dsPIC30F Family Reference Manual Errata Sheet

The dsPIC30F Family Reference Manual (DS70046B) correctly describes the function of the dsPIC30F devices, except for the anomalies described below.

Figure 5-2: NVM Addressing with TBLPAG and NVM Address Registers

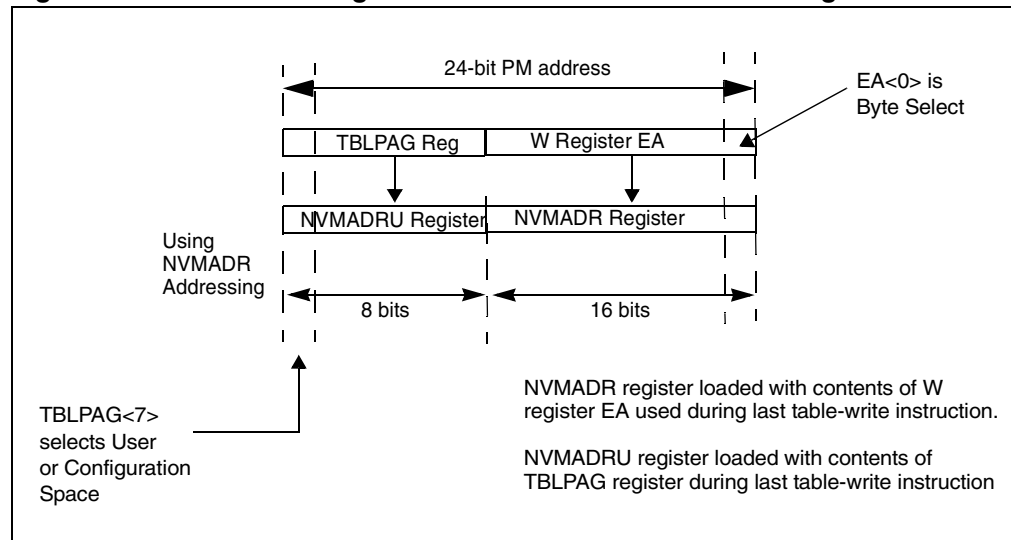
10. Page 5-6, Section 5.3.2 NVMADR Register

On page 5-6, Section 5.3.2 NVMADR Register should be replaced with the following:

5.3.2 NVM Address Registers

There are two NVM Address Registers - NVMADRU and NVMADR. These two registers when concatenated form the 24-bit effective address (EA) of the selected row or word for programming operations. The NVMADRU register is used to hold the upper 8 bits of the EA, while the NVMADR register is used to hold the lower 16 bits of the EA.

The register pair, NVMADRU:NVMADR, capture the EA<23:0> of the last table-write instruction that has been executed and select the row of Flash or EEPROM memory to write/erase. Figure 5-2 shows how the program memory EA is formed for programming and erase operations.

Although the NVMADRU and NVMADR registers are automatically loaded by the table-write instructions, the user can also directly modify their contents before the programming operation begins. A write to these registers will be required prior to an erase operation, because no table-write instructions are required for any erase operation.

Figure 17-21: 10-bit A/D Converter Analog Input Model

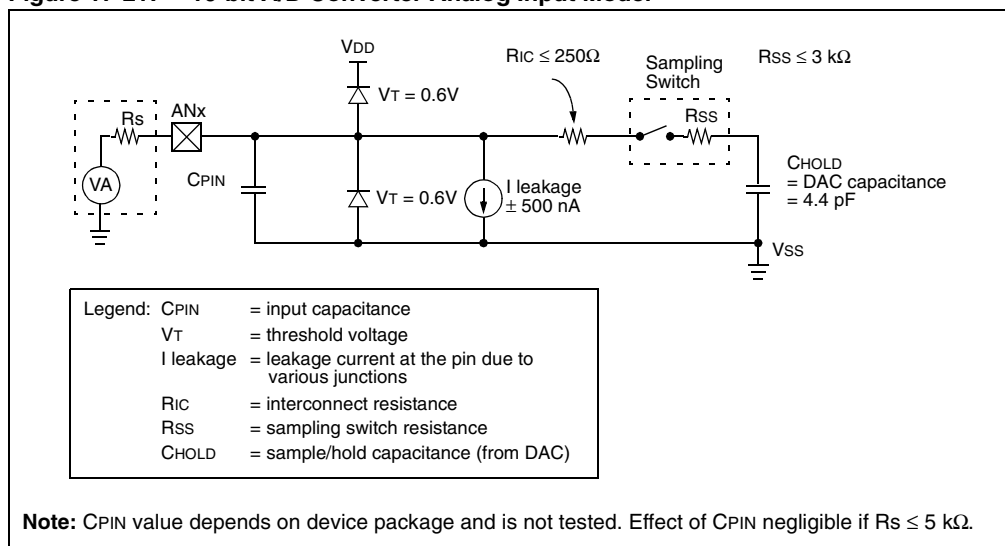
32. Page 17-46, Section 17.16 A/D Sampling Requirements

The entire Section 17.16 should be replaced with the following text and figures:

The analog input model of the 10-bit A/D converter is shown in Figure 17-21. The total sampling time for the A/D is a function of the internal amplifier settling time and the holding capacitor charge time.

For the A/D converter to meet its specified accuracy, the charge holding capacitor (CHOLD) must be allowed to fully charge to the voltage level on the analog input pin. The source impedance (RS), the interconnect impedance (RIC), and the internal sampling switch (RSS) impedance combine to directly affect the time required to charge the capacitor CHOLD. The combined impedance of the analog sources must therefore be small enough to fully charge the holding capacitor within the chosen sample time. To minimize the effects of pin leakage currents on the accuracy of the A/D converter, the maximum recommended source impedance, RS, is 5 kΩ. After the analog input channel is selected (changed), this sampling function must be completed prior to starting the conversion. The internal holding capacitor will be in a discharged state prior to each sample operation.

At least 1 TAD time period should be allowed between conversions for the sample time. For more details, see the device electrical specifications.

Figure 18-11: 12-bit A/D Converter Analog Input Model

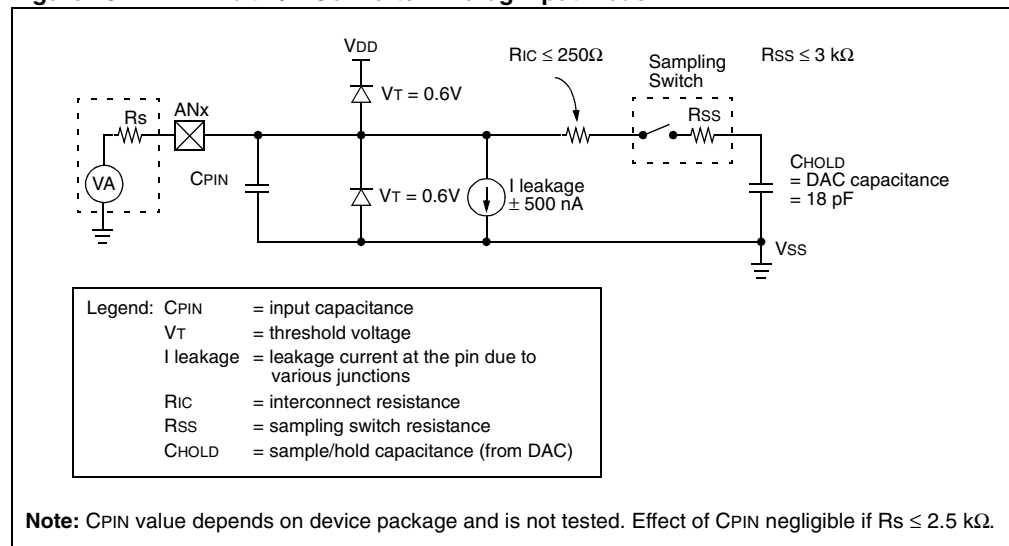
34. Page 18-27, Section 18.15 A/D Sampling Requirements

The entire Section 18.15 should be replaced with the following text and figures:

The analog input model of the 12-bit A/D converter is shown in Figure 18-11. The total sampling time for the A/D is a function of the internal amplifier settling time and the holding capacitor charge time.

For the A/D converter to meet its specified accuracy, the charge holding capacitor (CHOLD) must be allowed to fully charge to the voltage level on the analog input pin. The source impedance (R_s), the interconnect impedance (R_{ic}), and the internal sampling switch (R_{ss}) impedance combine to directly affect the time required to charge the capacitor CHOLD. The combined impedance of the analog sources must therefore be small enough to fully charge the holding capacitor within the chosen sample time. To minimize the effects of pin leakage currents on the accuracy of the A/D converter, the maximum recommended source impedance, R_s , is 2.5 k Ω . After the analog input channel is selected (changed), this sampling function must be completed prior to starting the conversion. The internal holding capacitor will be in a discharged state prior to each sample operation.

At least 1 TAD time period should be allowed between conversions for the sample time. For more details, see the device electrical specifications.
